# DART SERVICE BULLETIN SB12-1

**D350-607-441/-443/-445/-447/-541/-543/-545/-547 HELI-UTILITY-BASKET  
INSTALLATIONS AT CHANGE 003 OR EARLIER**

REF TCCA STC: SH94-14  
FAA STC: SR00213NY  
REF EASA STC: 10016996  
REF ANAC STC'S: 2007S03-03/-04/-05/-06

AFFECTING:

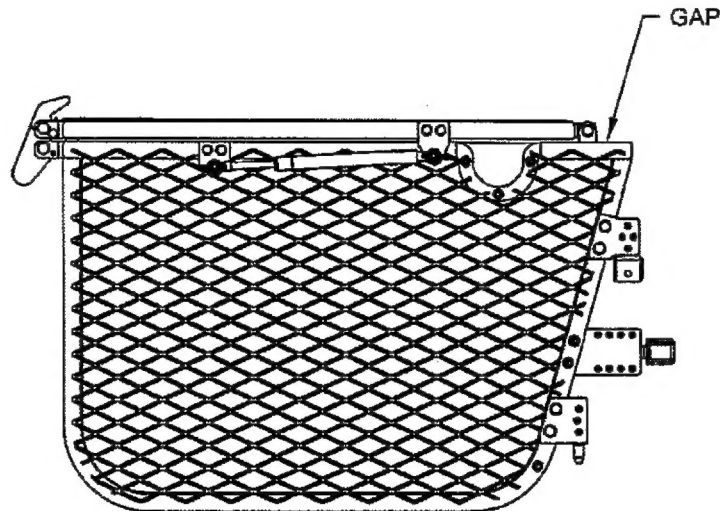
Dart Aerospace Ltd. has received information indicating that under certain circumstances on **D350-607-441/-443/-445/-447/-541/-543/-545/-547** Heli-Utility-Basket Installations at **CHANGE 003 or earlier**, thin flexible objects such as an unsecured retaining strap can find their way out of the basket through the narrow opening located along the top inboard side of the basket base assembly and cause damage to the aircraft and/or depart from the basket in flight.

For operators with aircraft equipped with **D350-607-441/-443/-445/-447/-541/-543/-545/-547** Heli-Utility-Basket Installations at **CHANGE 003 or earlier** it is recommended that the opening described above be closed off with D4672-X Blanking Plates using the DSI 9618-011 Blanking Plate Kit (for D350-607-441/-443/-541/-543 Heli-Utility-Basket, Long) and DSI 9618-013 Blanking Plate Kit (for D350-607-445/-447/-545/-547 Heli-Utility-Basket, Short) per **DSI 9618 Rev. A** (or later approved revision).
